CITY OF LADUE ZONING AND PLANNING STAFF REPORT July 20, 2026

PLANNED DEVELOPMENT DISTRICT – GENERAL DEVELOPMENT PLAN (ZPC 26-10)

Location: Property surrounding the Rock Hill Quarries Landfill at McKnight and Old Warson. Lot A of Rock Hill Quarries, Plat 2. (1200 N. Rock Hill Road, 1233 N. Rock Hill Road, 1341 N. Rock Hill Road, 2577 S. McKnight Road)

New Floodplain/ Floodway map (floodplain is blue, floodway is red and blue stripes)

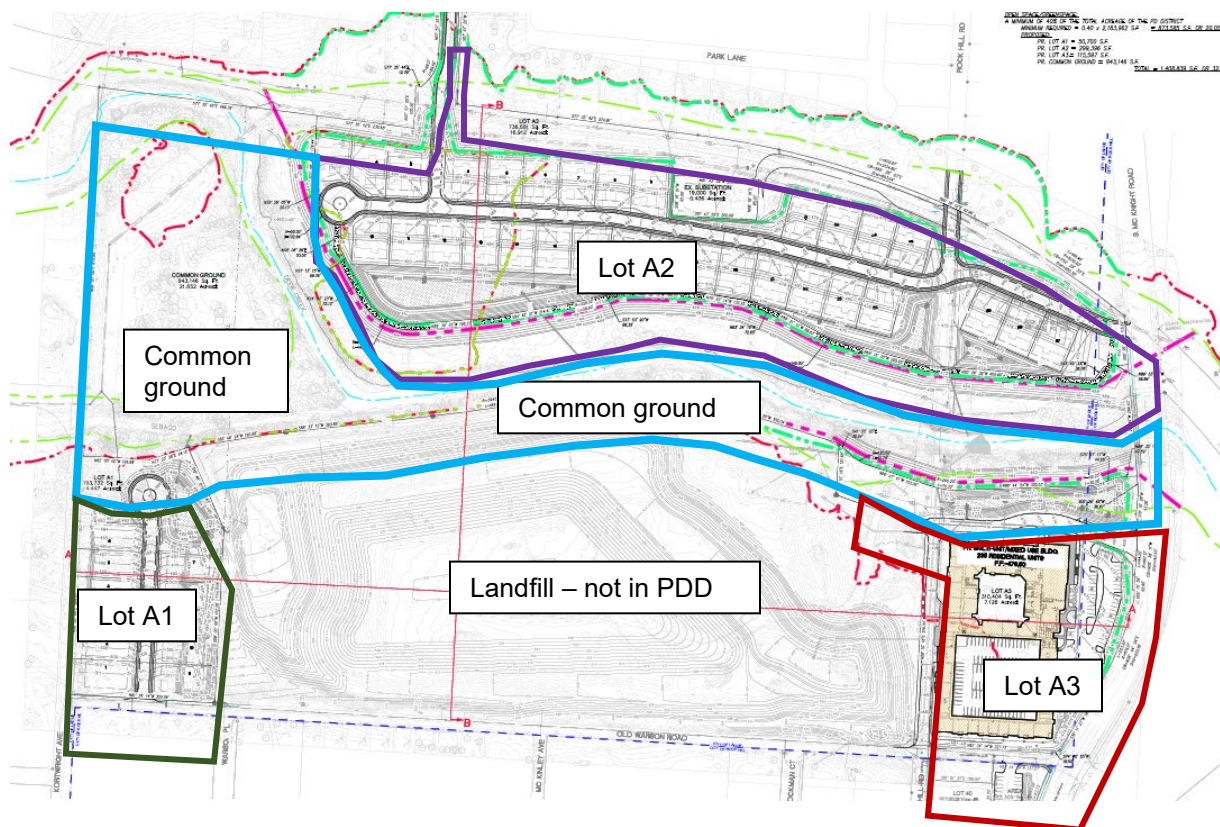
A significant percentage of this property is considered floodplain and floodway based on the current land elevations, as shown on this floodplain map image. A floodplain development permit is required to develop this property. Development must comply with Ladue Floodplain Regulations.

Existing Conditions Model.

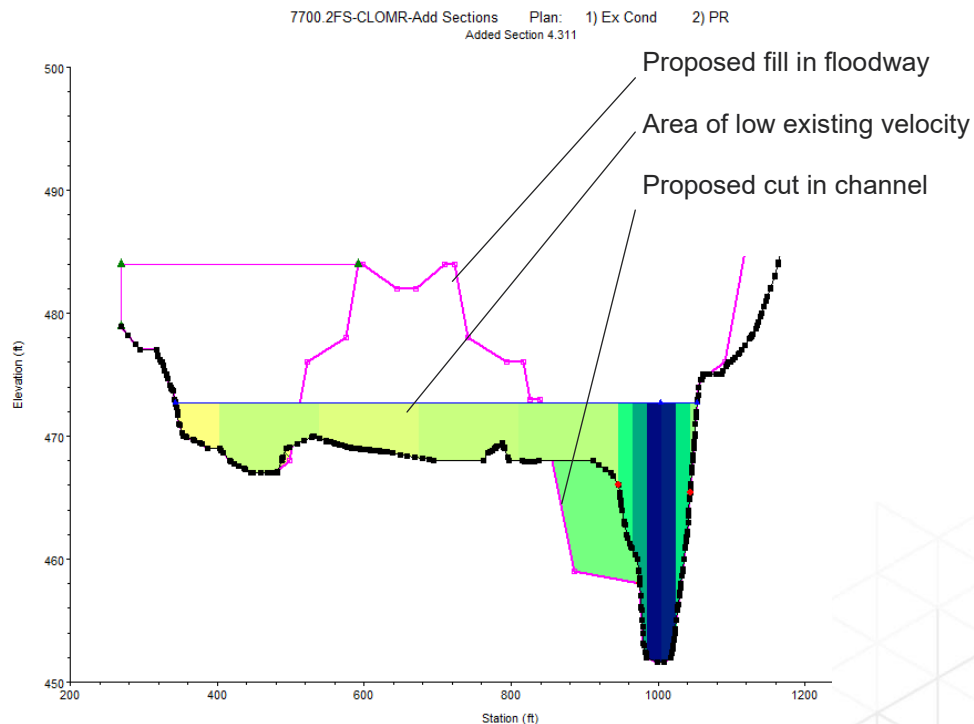
The developer incorporated recent aerial topography into an existing conditions model. The topographic changes that are below the BFE are small.
